Cc:Scott Moore; Breezy Rinehart-Young; Greg MinoSubject:RE: Introduction: Delta Logistics Wilsonville Annex/ZC

Delta Logistics

To:Greg Mino; Lee D. Leighton; Breezy Rinehart-YoungSubject:RE: Delta Logistics Annex Day Road Access Discussion

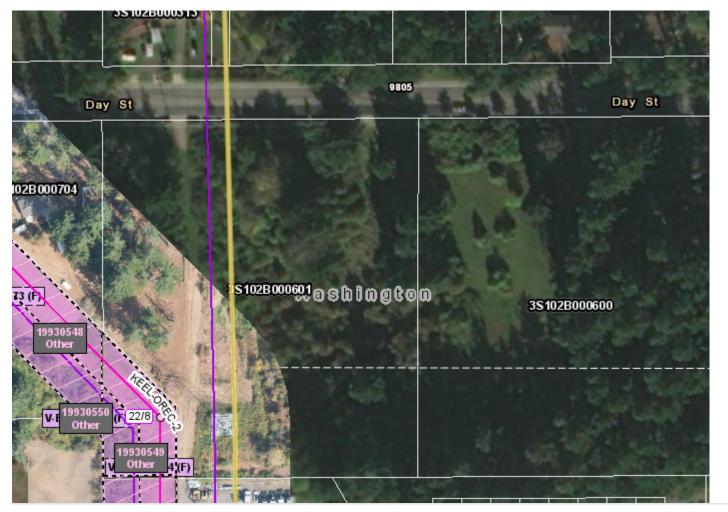
The corridor is fee owned, BPA owns this corner as you see in light purple, the lines going North and South are PGE and you will need to coordinate with them. If you are applying to use any of our fee owned right of way that may take a year or so due to environmental etc. If you can stay out of our fee owned you do not need to submit application

No work is proposed outside Delta Logistics's fee ownership, which is to say the fee-owned BPA corridor to its west will not be affected.

We will coordinate with PGE regarding improvements and activities within the PGE easement area.

Proposed Driveway Location

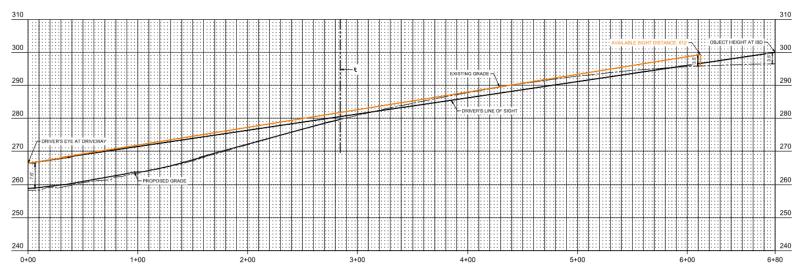
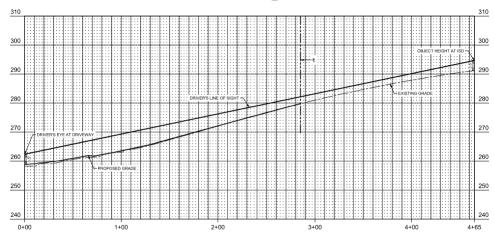
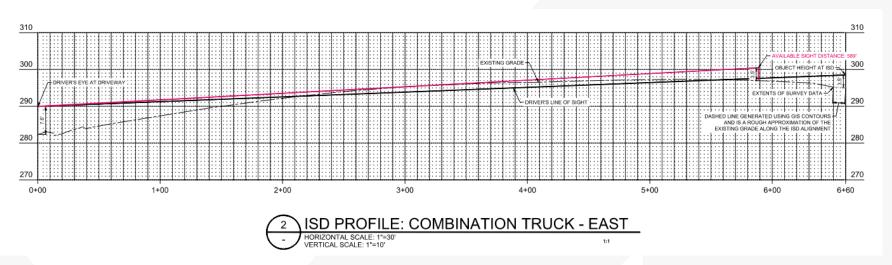
Available sight distance to east (trucks): ~610 feet

More than 465' available sight distance to east for passenger cars.

City's Recommended Shared Driveway Location

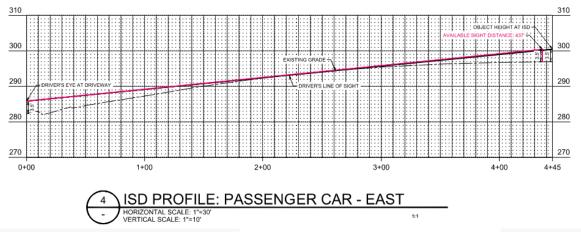
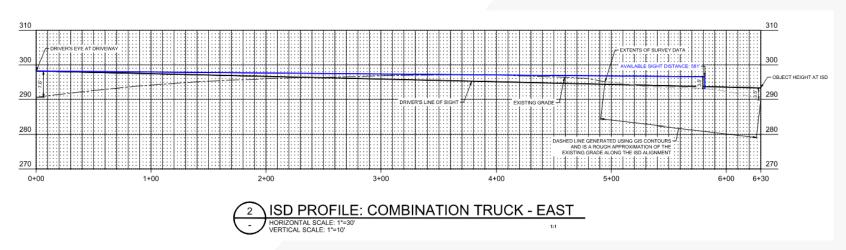
Available sight distance to east (trucks): ~590 feet

Available sight distance to east (cars): ~440 feet

Alternative Access Location for Adjacent Property

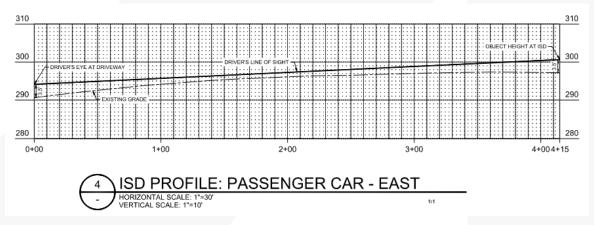
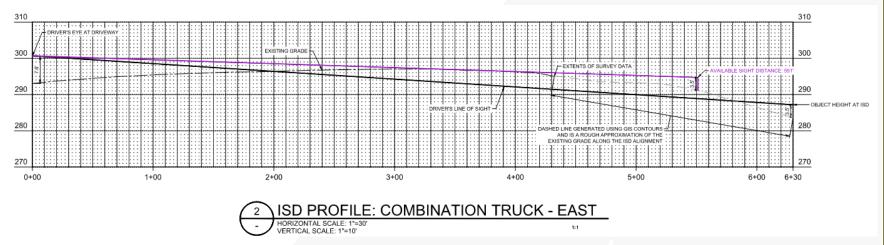
Available sight distance to east (trucks): ~580 feet

Available sight distance to east (cars): ~480 feet

Alternative Shared Access Location for Adjacent Properties

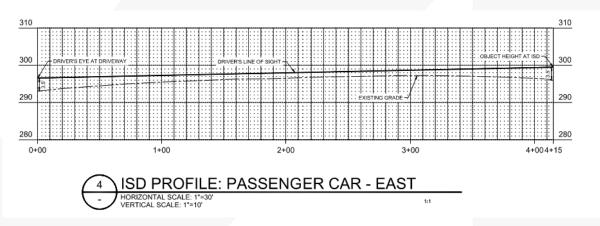
Available sight distance to east (trucks): ~550 feet

Available sight distance to east (cars): ~460 feet

Driveway Truck Turns
© 2022 | Mackenzie | 2220502.00

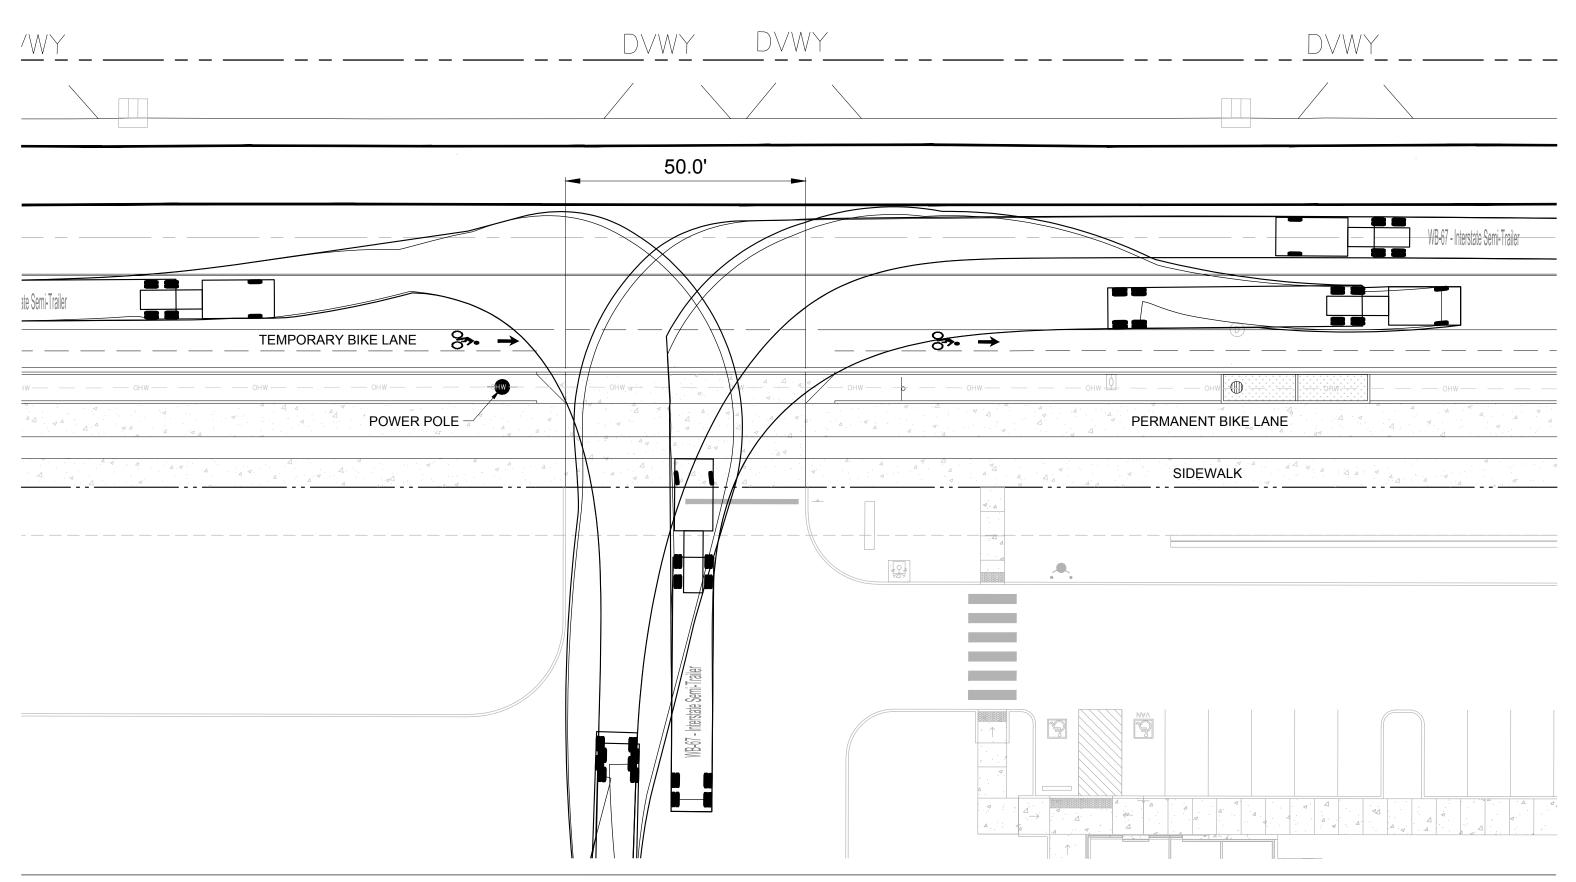
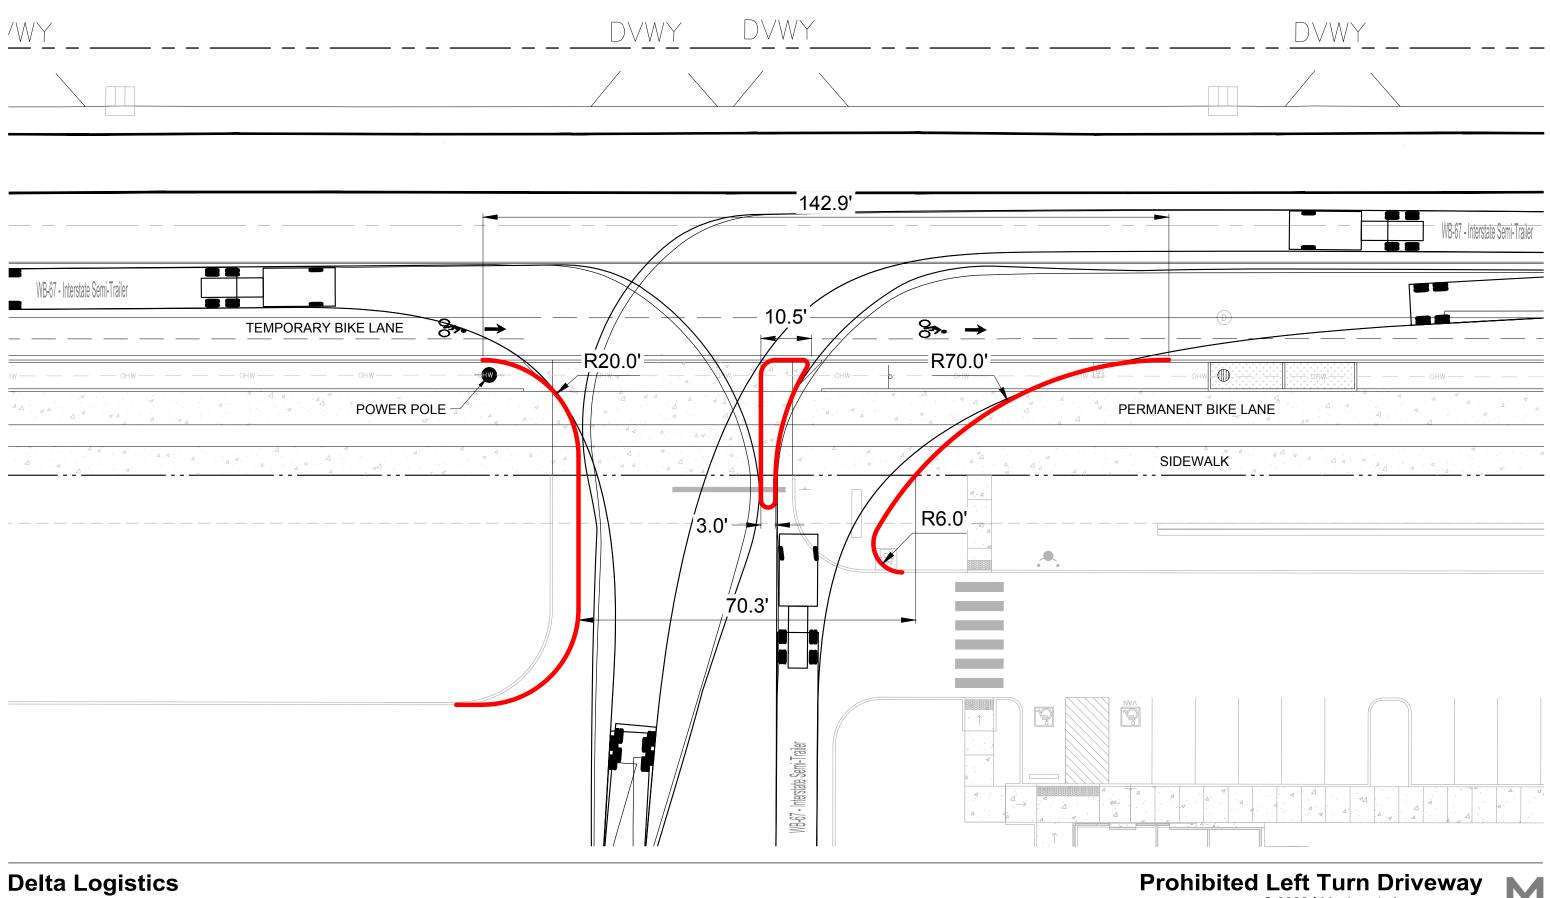
Option 1 - Driveway Median

Our review shows the median option has a significant impact on the more vulnerable pedestrian and bicyclist population. Truck turn simulations for a WB-67 design vehicle show a much wider driveway apron would be required with a driveway median, increasing the conflict area between vehicles and pedestrians/bicyclists. This design would require a 70' radius for exiting trucks resulting in an approximately 143' wide driveway apron while providing only a 3-foot refuge in the median for pedestrians in the future. This is subpar to the preferred 8-foot refuge that is recommended by the FHWA and leaves approximately 100' of non-refuge area for pedestrians. Providing the additional 5 feet recommended in the median would result in an approximately 148' wide driveway apron with about 100' of non-refuge area.

Not only would this design require a very wide driveway apron that has adverse safety implications on pedestrians and bicyclists, but the median geometry may not be adequate in physically restricting left turns onto SW Day Road. A turn-restricting median for this industrial driveway is not appropriate and may compromise the safety of pedestrians and bicyclists.

Sorry for the delayed response on this. The City would be accepting of Option 2 – Signage with the condition that in the future the City may modify the access as needed to ensure the long-term safety along the corridor (I'll be working with our legal department on exact language).
